City of Richmond

Report to Development Permit Panel

File: DP 10-521415

Re: Application by Matthew Cheng Architect Inc. for a Development Permit at 6551 Williams Road (formerly 6511/6531 and 6551/6553 Williams Road)

DWG. TITLE:
Landscape Plan

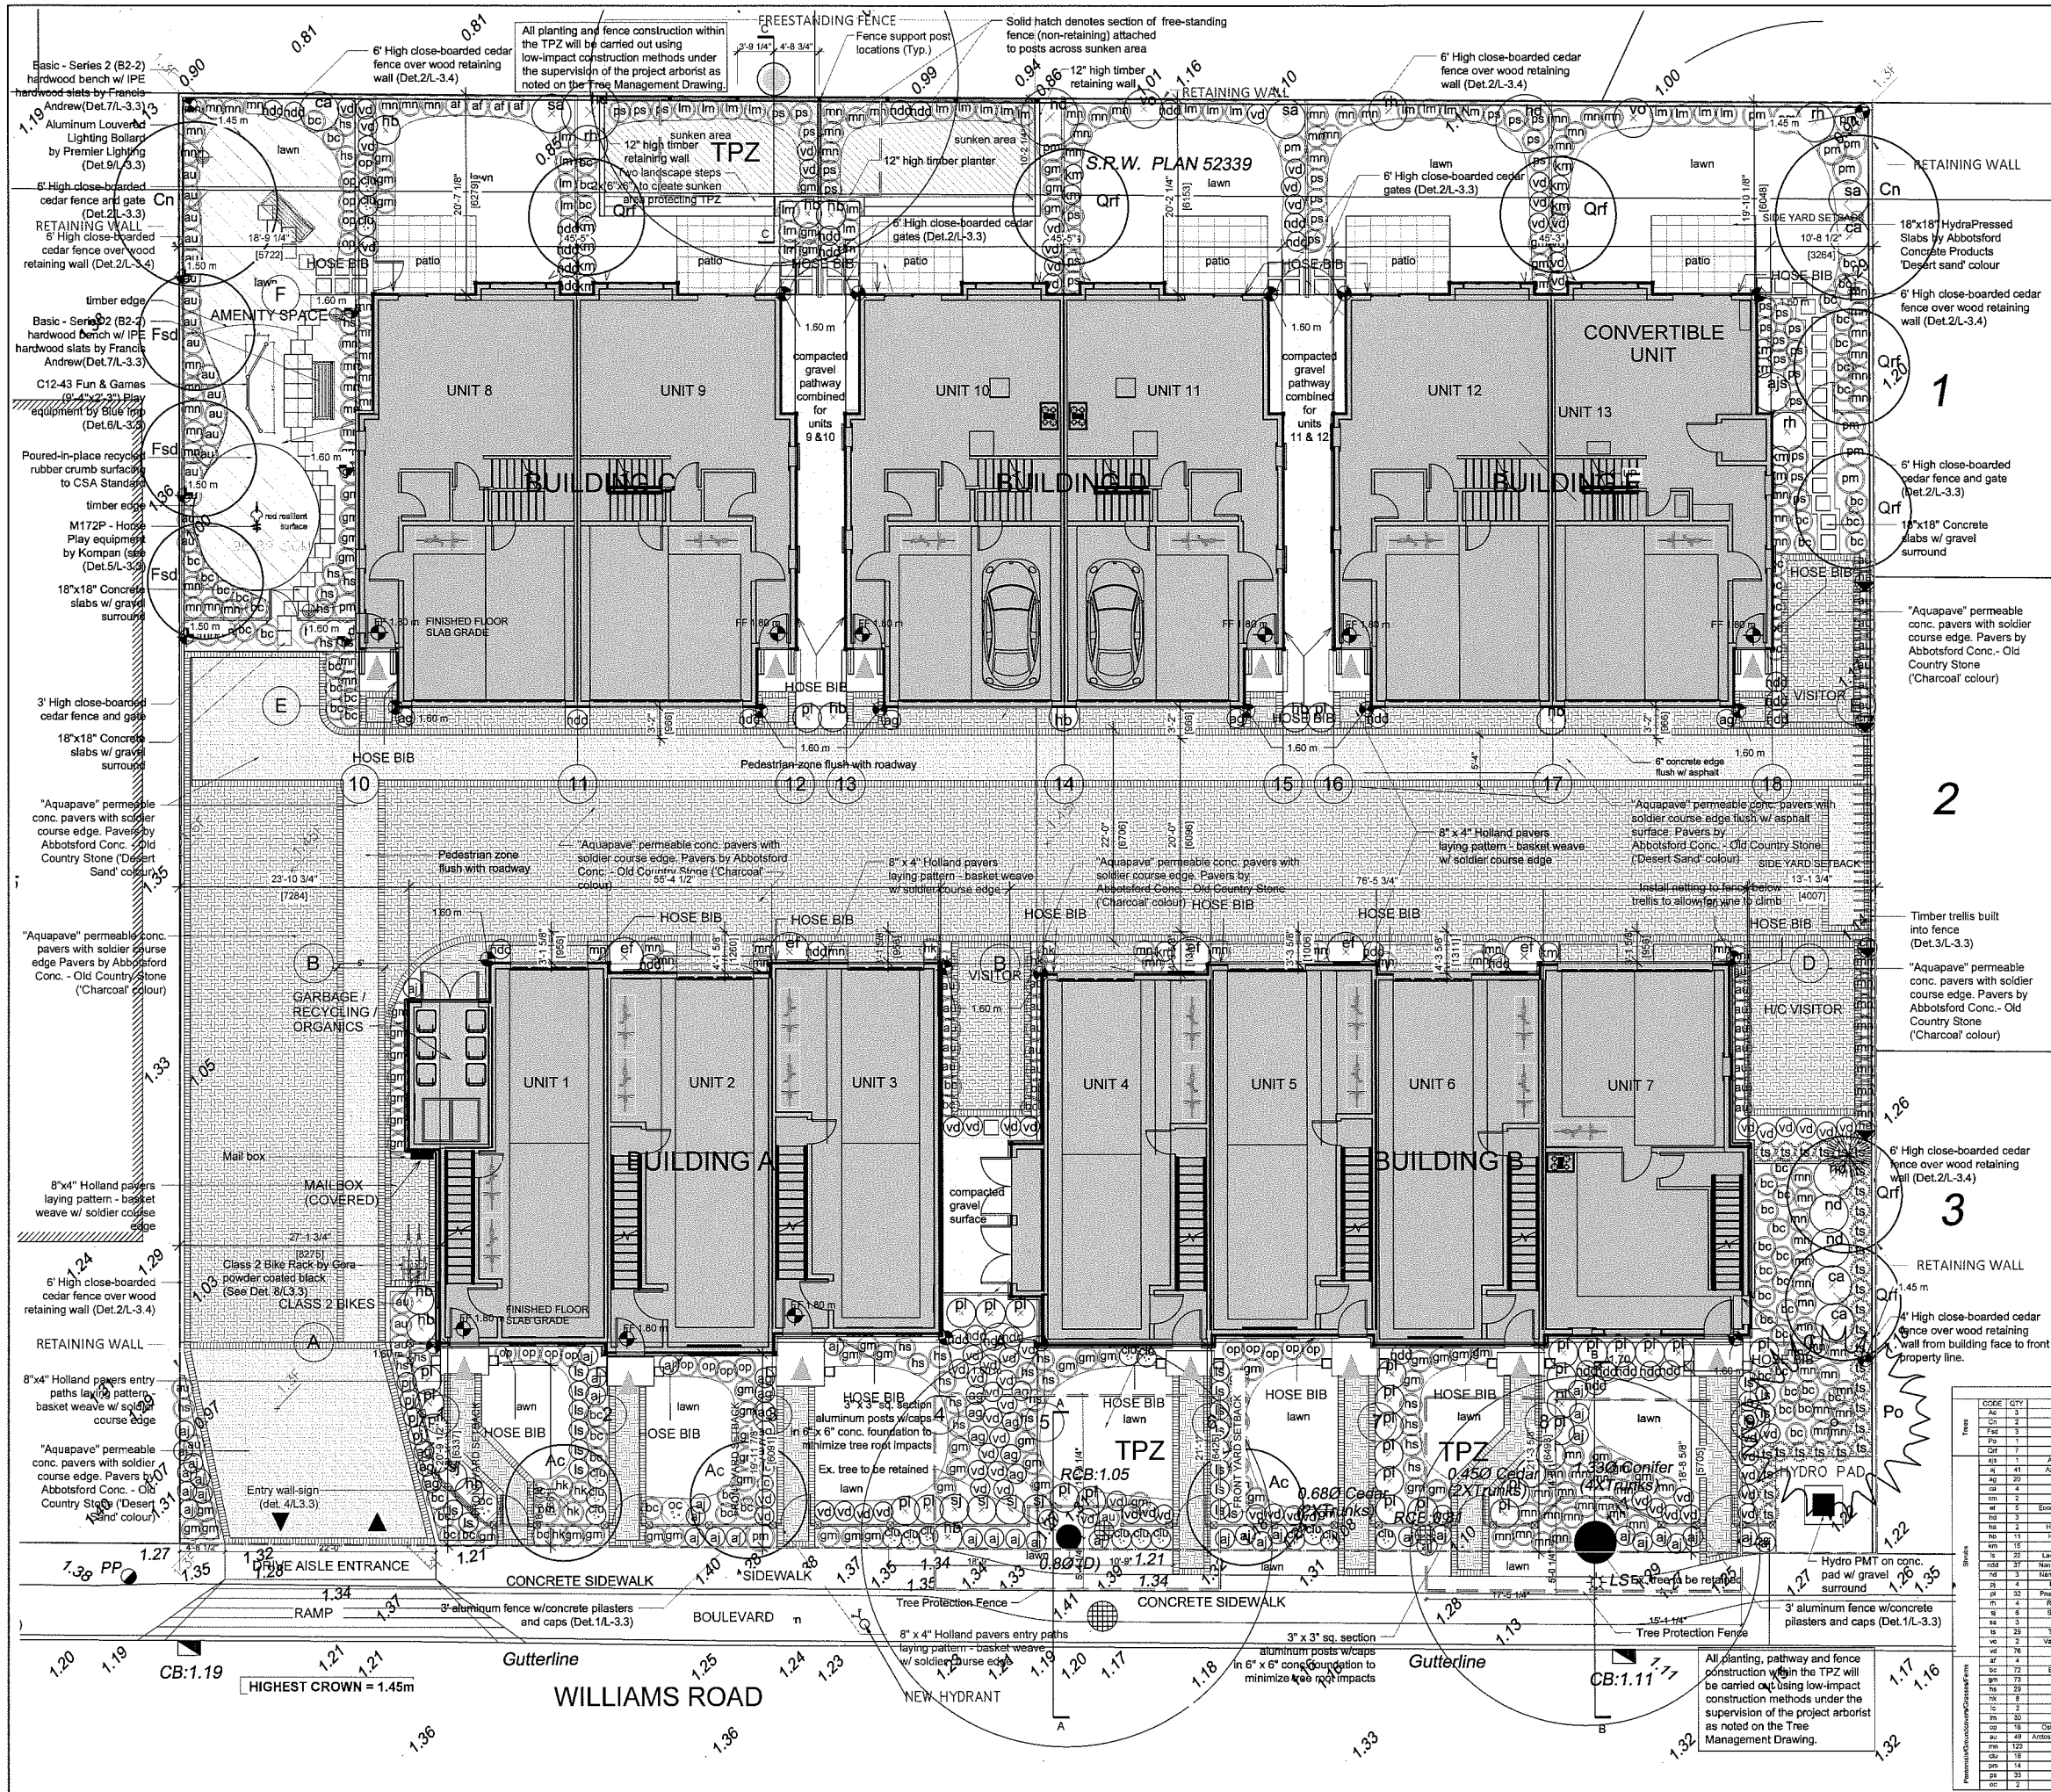
- appreciate the proposed paving materials for the entire internal drive aisle; however, consider introducing planting along the internal drive aisle;
We have reviewed this issue previously at City request and do not see any way to add any further planting to the sides of the drive aisle. All possible opportunities for inserting planting have been maximized. More low planting is now added around the visitor parking stalls off the south side of the drive aisle to increase soft landscape in the only spaces available.

- review the height of proposed planting inside the proposed development; consider incorporating vertical evergreens such as cedars along the internal drive aisle;
We have reviewed the question of adding vertical evergreens such as cedars along the internal driveway. We believe it would not be an appropriate solution from a CPTED point of view and would impede sightlines when exiting the garages. We will install additional climbing plants at the east property line fence and these will be trained along the trellis feature from the planting areas on both sides of the end of the drive aisle. This will provide a "green-wall" effect on the fence and trellis structure once established. Planting is clearly indicated between garages and at the gaps between the rear units with mature plant sizes appropriate to the planting spaces available.

- review the use of gravel as landscaping materials adjacent to the entrances to the units off the internal drive aisle as they make planting difficult; consider planting shade tolerant shrubs near the unit entrances to enhance visual interest.
The intention in providing gravel surfacing between the units off the drive aisle was to provide a basic low-maintenance finish for what would be mostly used for occasional landscape maintenance access. Planting at any point in these spaces between units on the north side of the drive aisle would be very difficult to establish due to the dry conditions brought about by roof overhangs.

[illegible]ELEVATIONS -
BUILDING A, B

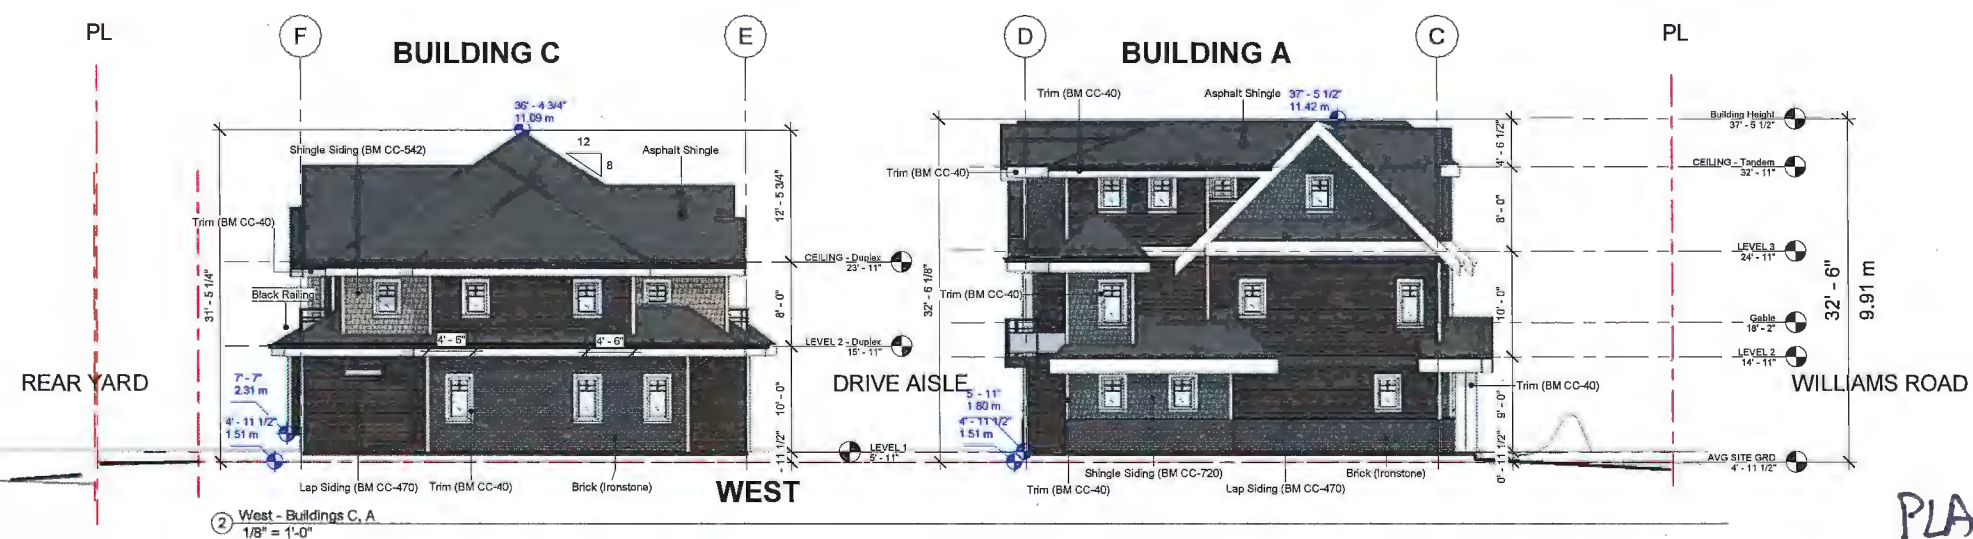
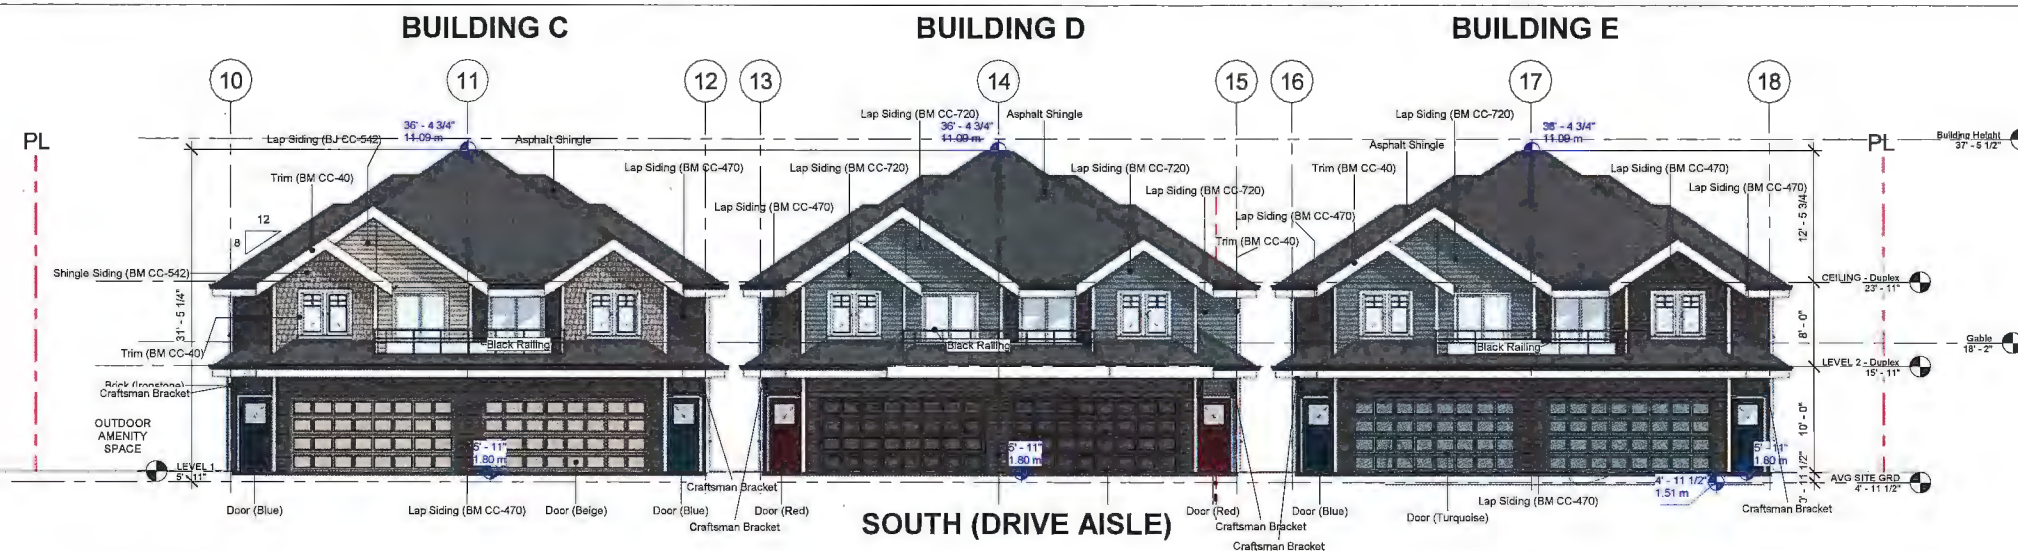
- consider design development to the quarter shed roofs that project up on the third floor in the middle of the south elevation facing Williams Road as they detract from the overall composition of the buildings;
The mentioned quarter shed roof has been removed, instead the existing quarter shed roof at the grid A, 2 and 3, Building A, has been continued to the middle of the South elevation, as well as Building B.

- consider lowering the height of entry gables along Williams Road to provide relief to the windows above;
The height of entry gables has been decrease 10.5" from bottom of the above windows, changing the slope of the gables.
